40 Union St.
Substation

Project Name:	Central Maine Power Substation Improvements	Project ID:	2013-080
Address:	40 Union Street	CBL:	32-I-039
Applicant:	Central Maine Power		
Planner:	Nell Donaldson

RE: Staff Review Comments for Preliminary Level II Site Plan

TO: Nell Donaldson, Planner
FROM: Ashley Auger, E.I.T. & David Senus, P.E.
DATE: April 8, 2013
RE: CMP Substation – 40 Union Street

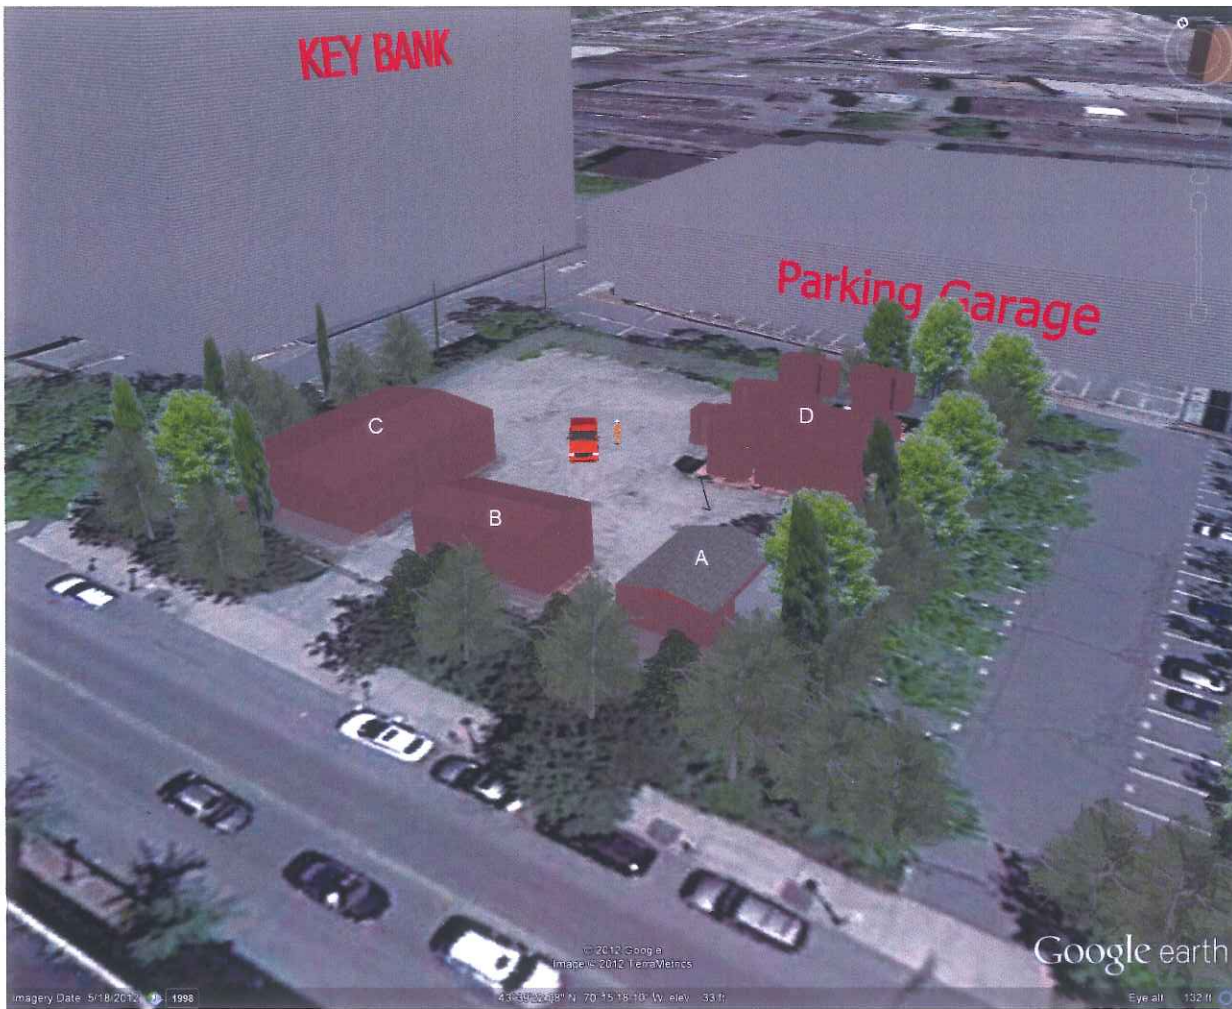
look @ existing signage. - CMP
color?

MARKS: m/d-f? →

what?
